AMENDMENTS TO THE DRAWINGS:

REMARKS

The Applicant thanks the Examiner for the thorough review and consideration of the pending application. The Office Action dated December 16, 2008 has been received and its contents carefully reviewed.

Fig. 5

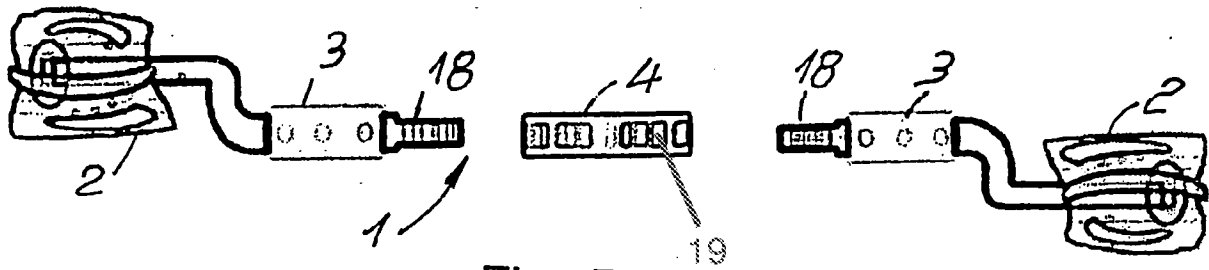
In Figure 5, reference number --19-- has been added. In Figure 11, reference number --29-- has been added. In Figure 21, reference number --51-- has been added. In Figure 26, reference number --58-- has been added. In Figures 27 and 28, reference number "61" has been amended to --62-- and reference number --66-- has been added to Figure 28. In Figure 40, reference number --83-- has been added and in Figure 41, reference number "83" has been amended to --86--. In Figure 44, reference numbers --97-- and --98-- have been added. In Figure 66, reference number "112" has been amended to --114--. In Figures 67, 68, 70, 71 and 74, reference number "38" has been amended to --118--. In Figure 69, reference number --124-- has been added.

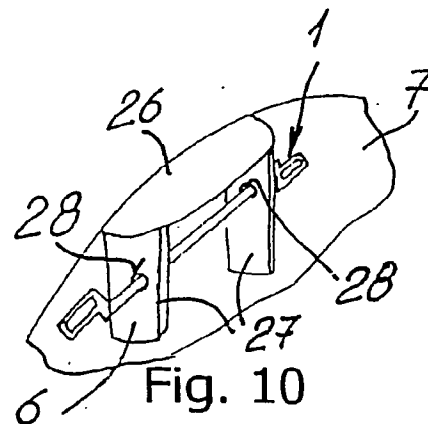
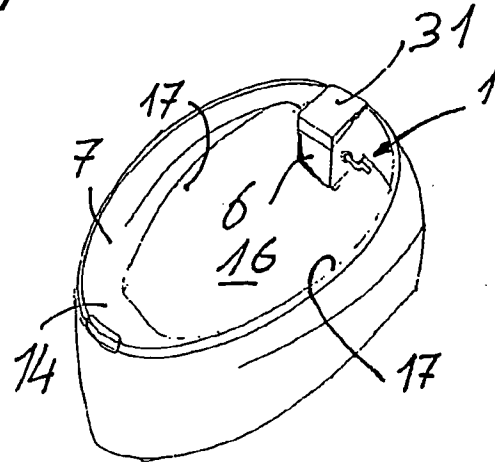
With regard to the objection that reference numeral 6 denotes different structures in Figs. 1, 2, 4 and 9-12, the Applicant respectfully disagrees.

The Applicant submits that reference numeral 6 is relied upon to identify supporting means for a pedaling assembly. The structure of the supporting means may be illustrated as having a different shape in the figures, however a different shape does not equate to different structural elements requiring different reference numbers. Therefore, reference numeral 6 does not denote different structures, but is relied upon to designate the element of "supporting means" in Figs. 1, 2, 4 and 9-12.
